Comment Resolution Status

Document: T10/01-328r6

To: T10 Committee Membership
From: Cris Simpson, Intel Corporation
Subject: Response to T10 Letter Ballot comments on SRP

This document contains T10/1415-D revision 14, the SRP Working Draft.

Figure 0.1 - IB I/O unit example

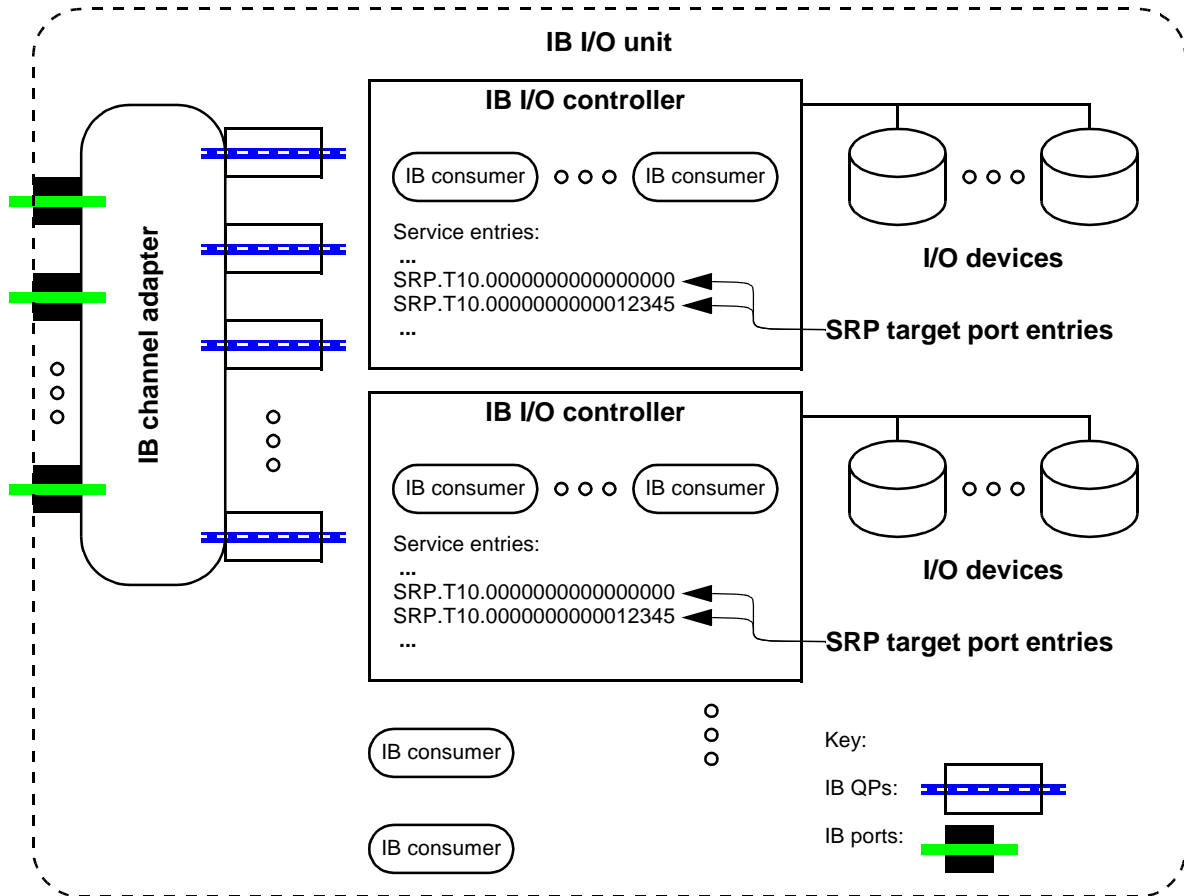
Figure B.3's equating of 'SRP Target Ports' with 'IB consumers' is problematic. A 'target port' is a sort of service access point---somewhere where interested parties initially go to obtain service, but without any implication that that's where the service is actually provided. (In IB, it's the Connection Manager that receives the initial connection request, interprets the ServiceID contained therein, and performs some magic that results in the instantiation of a QP bound to some entity that actually provides the target services). This target-services-providing entity fits the definition of 'IB consumer'. But the mapping of ServiceIDs-cum-SRP target ports onto such entities is clearly a matter of implementation, and could be one-to-many, many-to-one, or many-to-many Suggested Solution: One possibility: to the left of the IB Consumers show a table/list of service IDs within each IB I/O unit and label these entries as SRP Target Ports; use arrows to show a mapping from the entries to the IB Consumers, with e.g. one Consumer mapped to two IDs and another mapped to one ID to show that the mappings are not always 1 to 1. A further refinement might be to use another set of arrow between the Consumers and the QPs to show that the this mapping is also not 1 to 1

Notes from 28 Nov 2001 teleconference: show service entries in figures B.2 and B.3, in accompanying text explain that each service entry identifies an SRP target port.

This comment is correct, but it's not immediately obvious how to incorporate it into a legible diagram. Note the further complication introduced by connection redirection. The IB consumer (IB QP and the software, etc. behind it) may be in an unrelated device / node / whatever, it need not be the same channel adapter or even an I/O unit. The sole purpose of the I/O unit and I/O controller is to obtain a service ID, connecting to that service ID may lead somewhere else altogether.

The following is an attempt at a modified figure B.2 and the text describing service entries that identify SRP target ports

One or more service entries are associated with each IB I/O controller. A service entry contains a name and other information identifying an individual service provided by the IB I/O controller. A service entry may identify an SRP target port or a non-SRP service (e.g. a network interface service). Requirements for service entries that identify SRP target ports are described in table B.8.

Figure 1 - SCSI document relationships

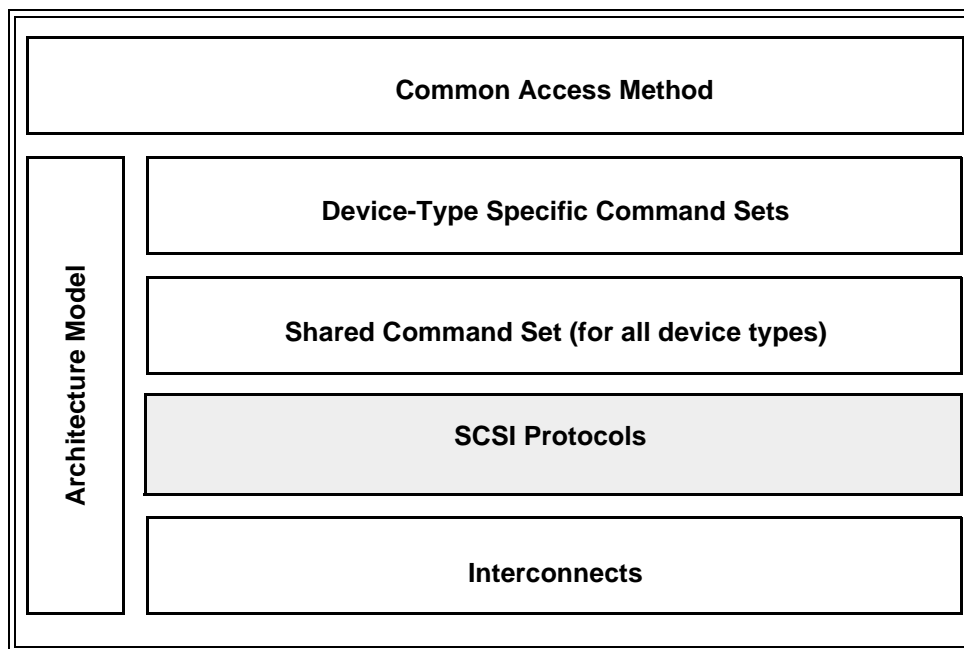
Delete CAM from figure 1 Delete these SCSI-2 standards from the example standards list:
Serial Storage Architecture SCSI-2 Protocol SSA-S2P [ANSI X3.294:1996] Common Access Method: SCSI Common Access Method CAM [ISO/IEC 9316-421] [ANSI X3.232:1996]
The 28 Nov 2001 teleconference voted that this be accepted.

"Figure 1 shows the relationship of this standard to the other standards?" But it doesn't. The SRP standard is not identified in the figure. Despite the disclaimer, layering of the blocks does suggest a hierarchy, protocol stack and system architecture. But the figure does not indicate the applicability of SRP to the implementation of a SCSI transport, as far as I can tell.

CRS: Propose that this comment be rejected. WG agreed Feb 15.

Figure 3 - Example RDMA channel establishment

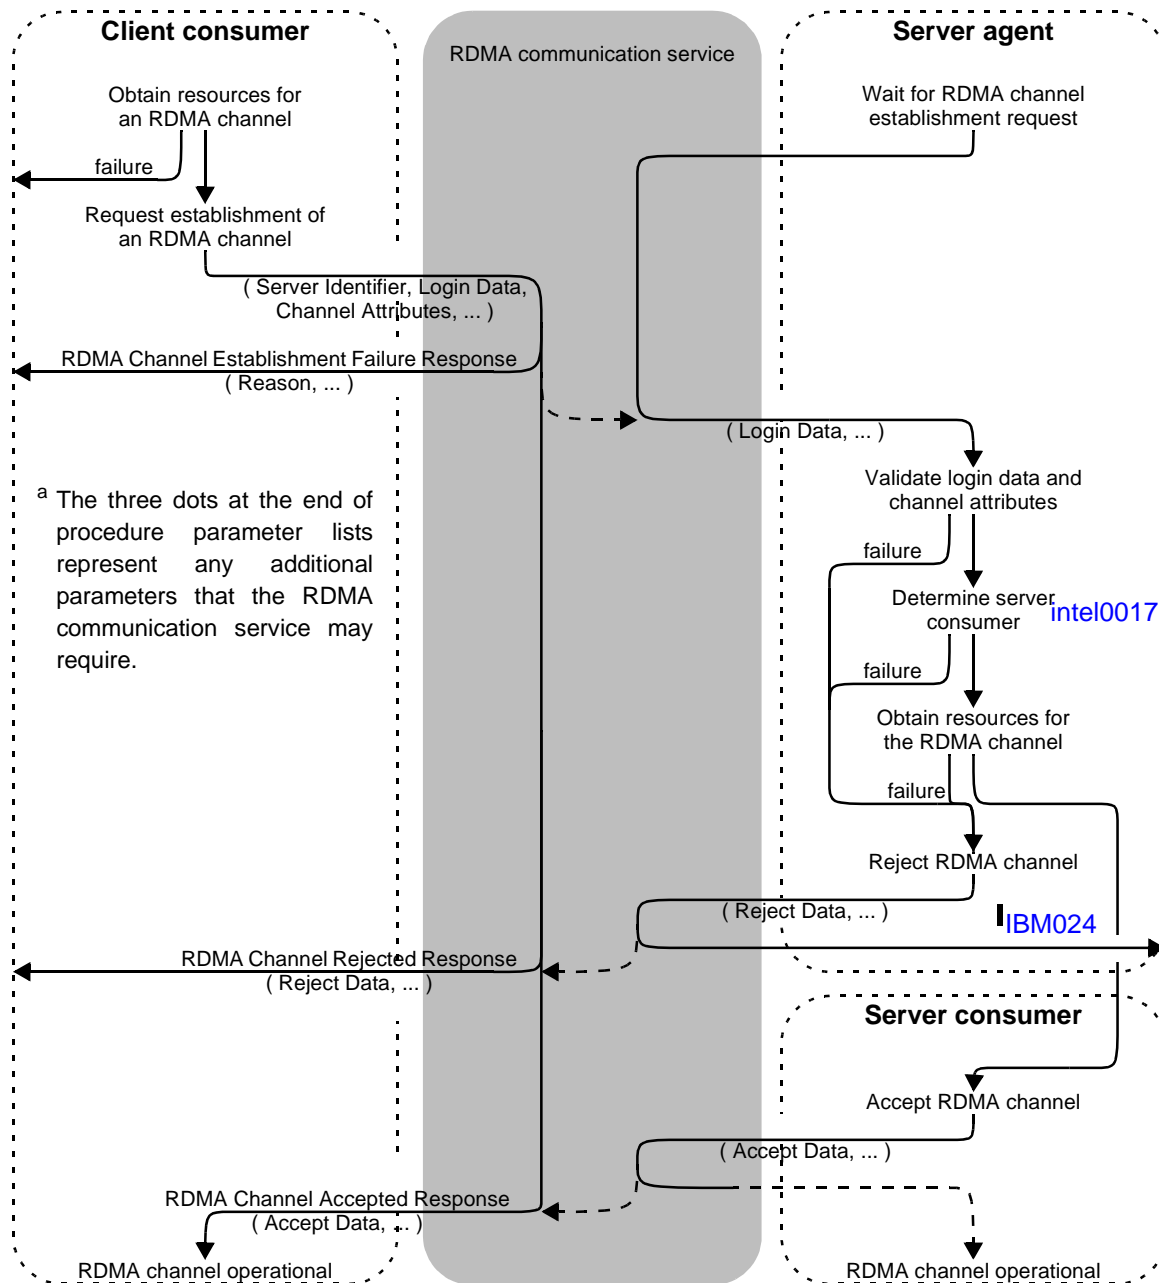
IBM021 page 9	Closed	
	Page 9 - lines 7-9 - The for example text should be change to (e.g.,).		
intel0016	IBM022 page 9	Open	
	Page 9 - line 2 - The statement '...directed to a server and, if...' is not clear because there is a server agent and a server consumer. Which is this server supposed to be?		
	IBM023 page 9	Open	
	Page 9 - line5 - The statement '...identify the server with which...' is not clear because t there is a server agent and a server consumer. Which is this server supposed to be?		
	IBM024 page 9	Open	
	Page 9 - Figure 3 - line 40 - The arrow exiting to the right seems to dead end. Where does the flow go from there. All the other exit points are clear that one is not.		
	IBM025 page 10	Open	
	say "server identifier" identifies a server containing one or more target ports.

Figure 4 - Memory descriptor mapping

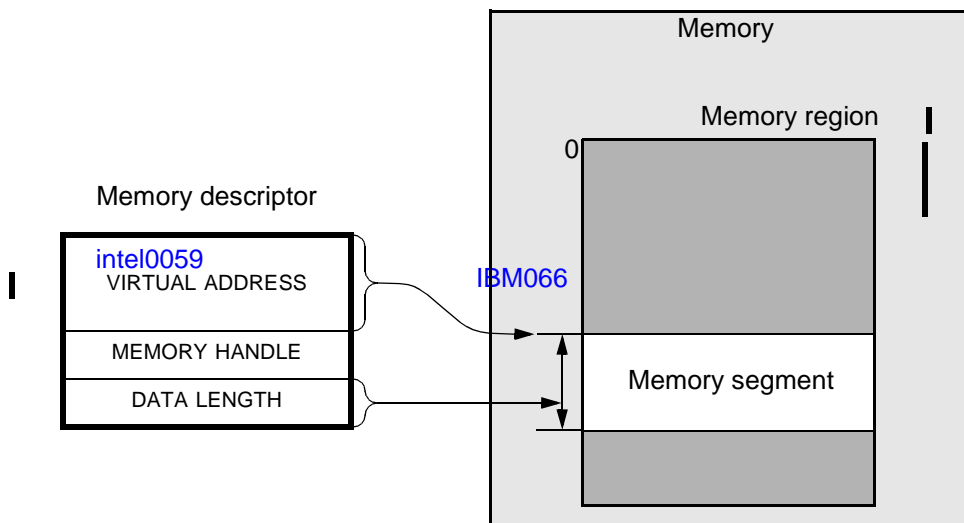
Page 17 - Figure 4 - The way the arrows are pointing for the virtual address implies that it is not the address of the first byte of the memory segment. It currently implies that it is the space from the memory handle to the beginning of the memory segment which is the memory region. It is also not clear as to what the boundaries are of the memory region. The current drawing implies it is only the area above the memory segment. I do not believe that is correct so it needs to be fixed.

Figure 5 - Example indirect data buffer descriptor with no PARTIAL MEMORY DESCRIPTOR LIST field

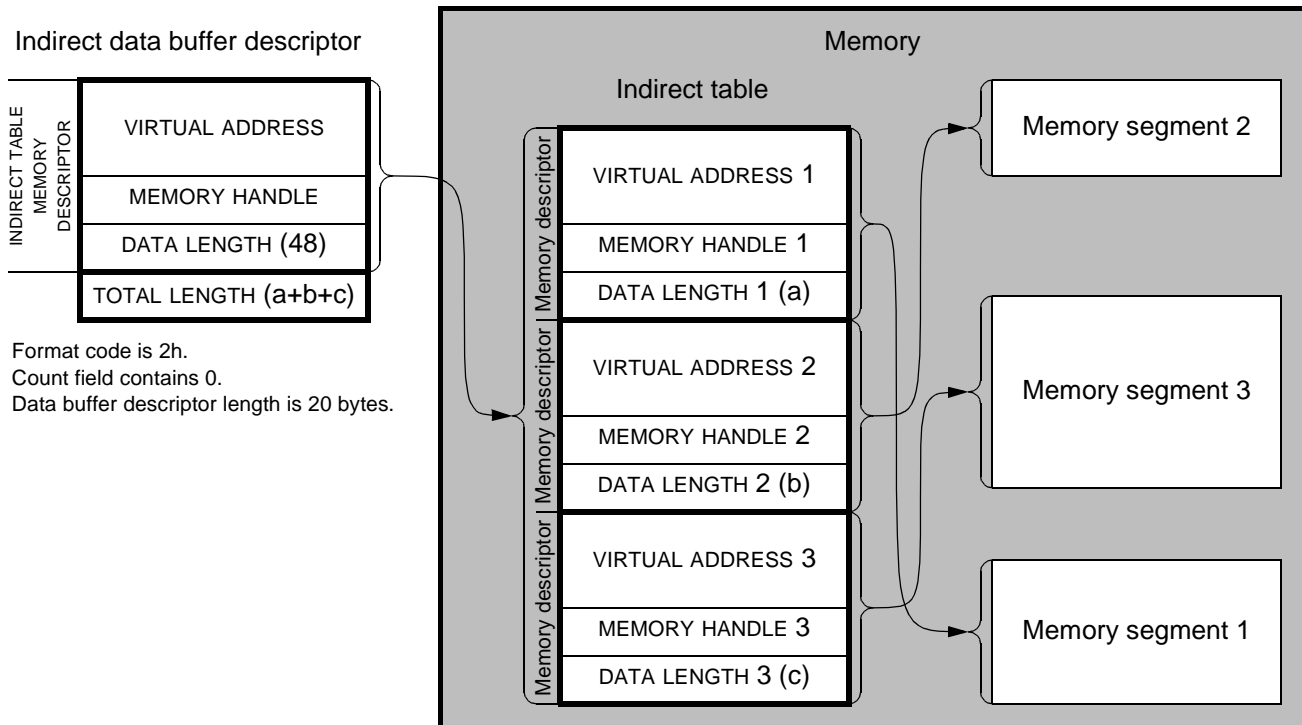
GOP: Says ref should be to FIGURE 5, not table 5.

Page 20 - line 12 - A reference to table 5 should be added to the end of the paragraph.

Figure A.2 - Model for a four-step confirmed service

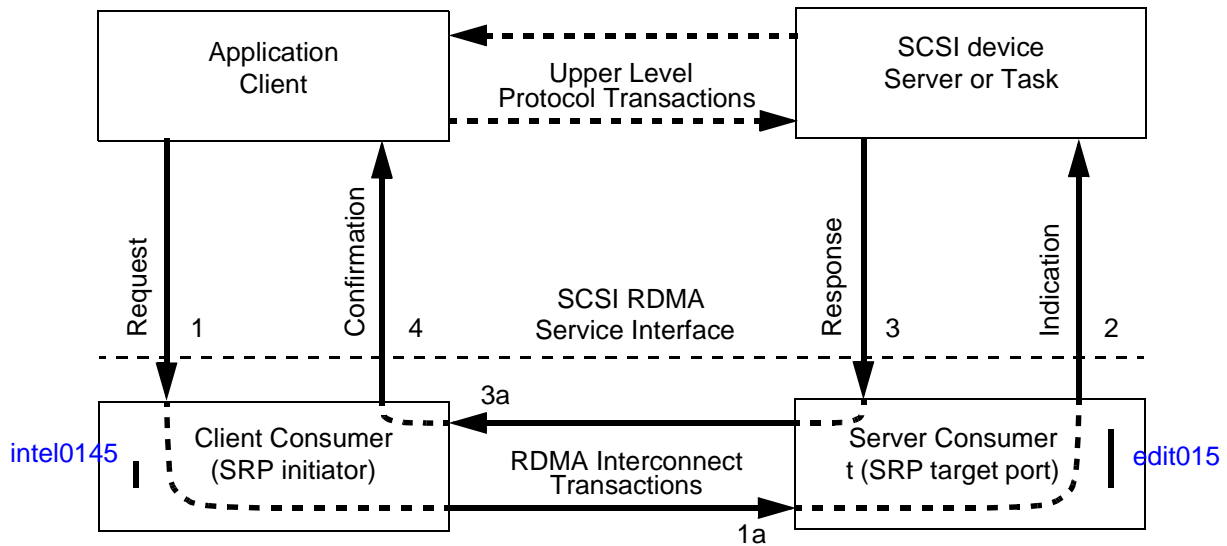
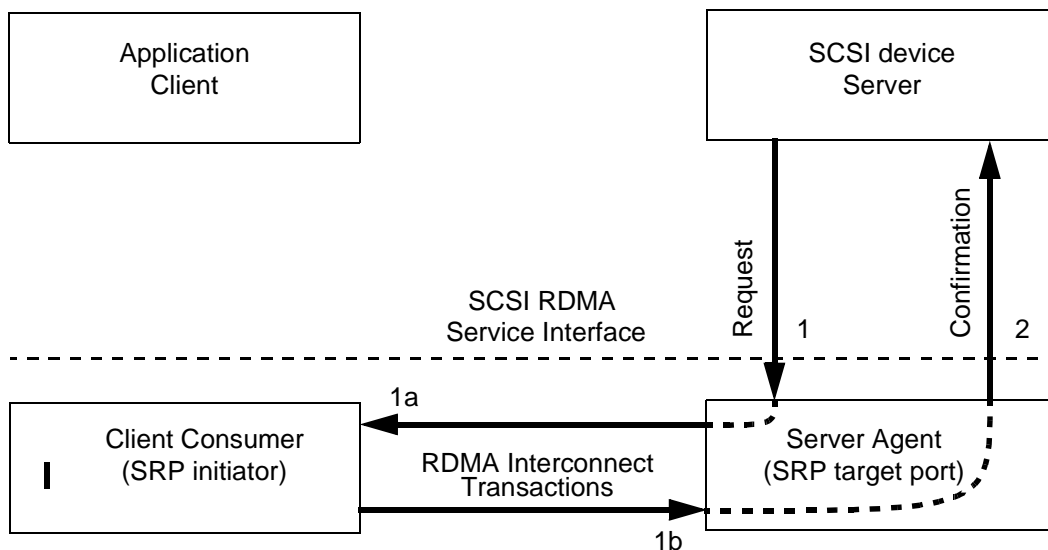
Page 46 - figure A.2 and A.3 - line 15 and 43 - The statement '(SRP initiator' should be '(SRP initiator port)'

Figure B.2 - IB I/O unit example

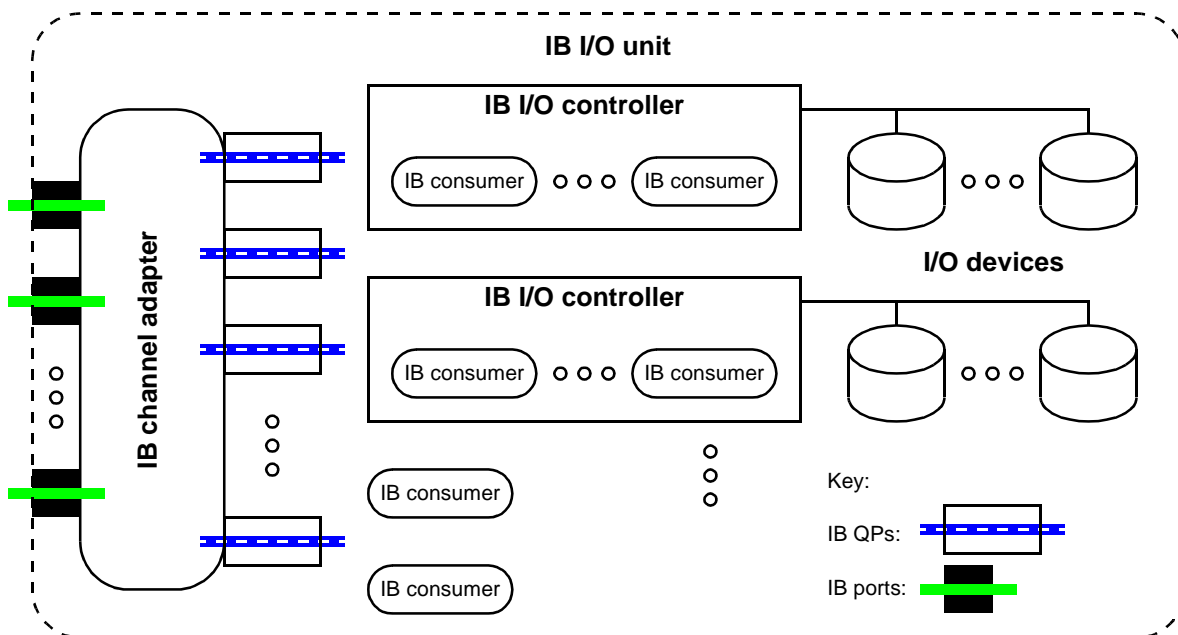
Figure B.2. Can I/O controllers be virtual objects?

Figure B.2. What is the purpose of allowing multiple IB consumers per IB I/O controller? Is it so that multiple IB connections can be terminated within an IB I/O controller? (This relates to the question above about correspondence between QPs and IB consumers.)

Figure B.2. How are shared LUs modeled? Do SRP target ports contain the "task router" function described recently by Penokie? Can two IB I/O controllers have an underlying LU in common, or is this functionality restricted to two IB consumers within the same IB I/O controller?

Figure B.3 - SCSI architecture mapping

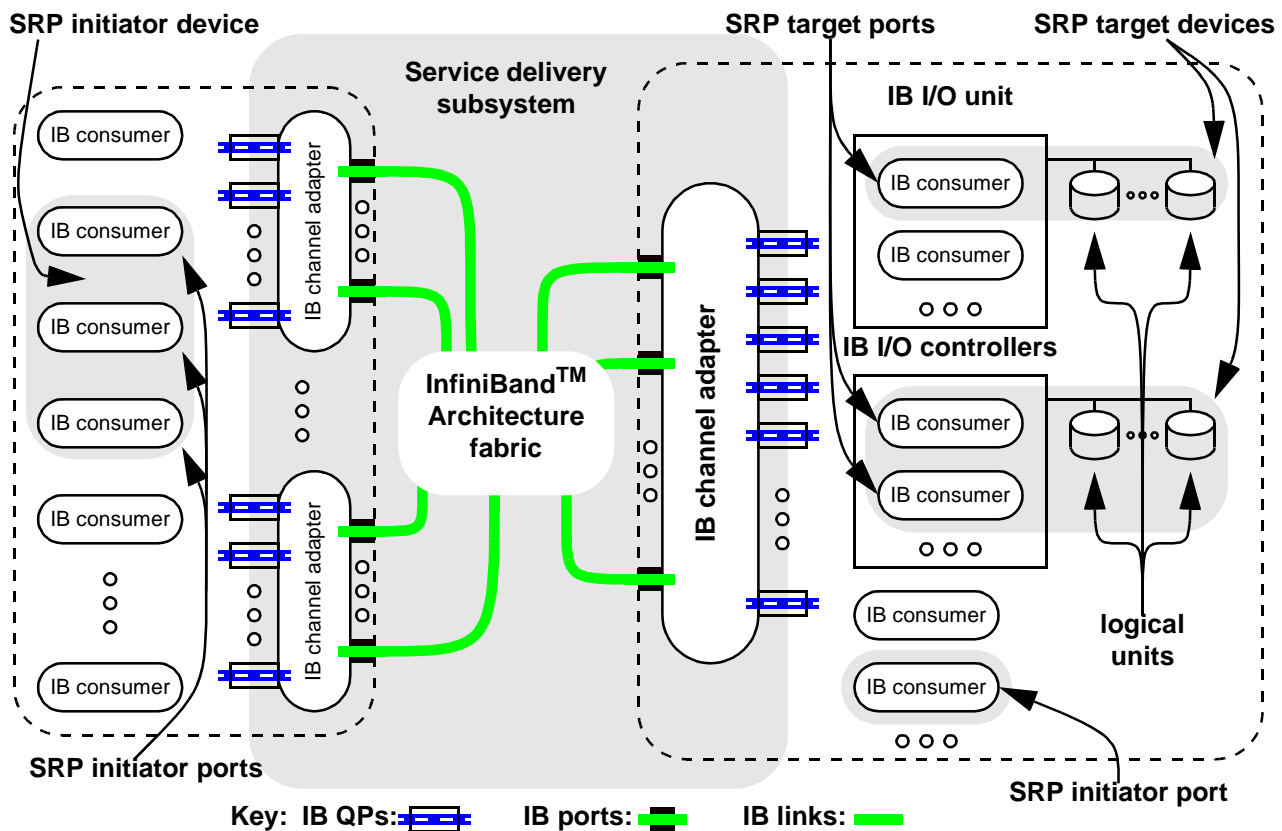
Figure B.3. What is the object indicated by the dashed lines in the initiator model, analogous to the IB I/O unit in the target model?

Figure B.3. and 56-1. Table B.2. The rules for constructing initiator ports seem entirely too lax. The text says, "Initiator port identifier should be constructed?" And then the Table indicates that GUID, for example, is the channel adapter GUID. Is there no meaning associated with the initiator port ID? Is the only design goal that the 16B port ID be globally unique? Will any GUID do at all? If so, let's be explicit about this, and **let's not make any suggestions about the origin (and possible meaning) of the port name.**

Feb15: Add a SRP-general description to Clause 5. In Anx B, Shall be a GUID (EUI?), should be a CA GUID + extension.
